City of Puyallup

FROM: Gabriel Clark, Planning Technician

PROJECT: PLPRE20220159

PROJECT DESCRIPTION (as provided by applicant): a new 6-story medical office building project w/ structured parking

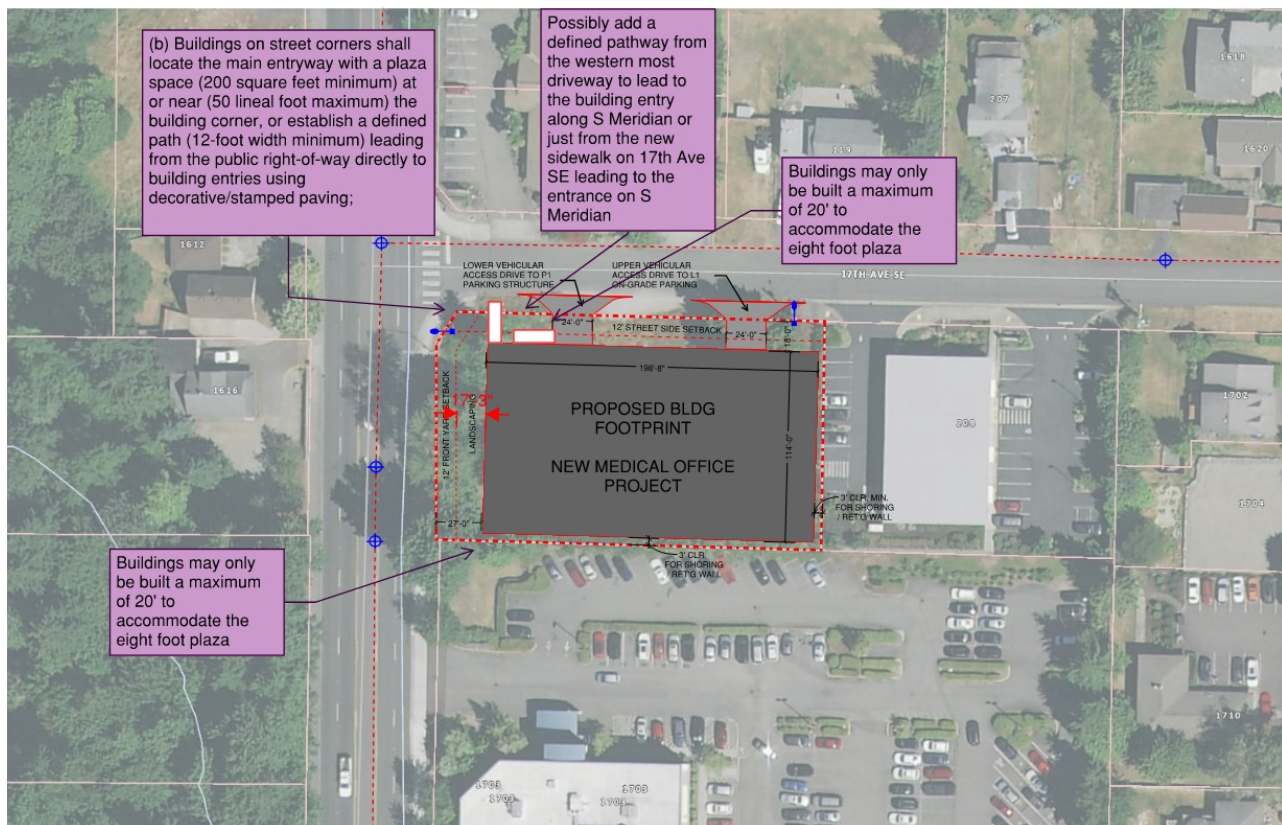
- This building is not eligible to apply for a height bonus for the building to be greater in height than the maximum allowed 50'. In order to be eligible for one or more of the height bonuses listed in PMC 20.30.032 (4), the building would have to be located more than 500 feet from a residentially zoned property.

- A pedestrian-oriented plaza space in front of the building at least eight feet deep running the full width of the building is required (PMC 20.30.037 (2)(a)).

- This area shall be covered by awnings covering at least six feet of the plaza space
 - Awning area needs to be over the pathway to entrance along 17th Ave as well

- Buildings on street corners shall locate the main entryway with a plaza space (200 square feet minimum) at or near (50 lineal foot maximum) the building corner, or establish a defined path (12-foot width minimum) leading from the public right-of-way directly to building entries using decorative/stamped paving (PMC 20.30.027 (2)(b)).

- New buildings shall be built 12 feet from the abutting front yard and street side yard right-of-way to improve pedestrian orientation and overall building design. Buildings may deviate from this setback under the following conditions (PMC 20.30.027 (2)(c)).:
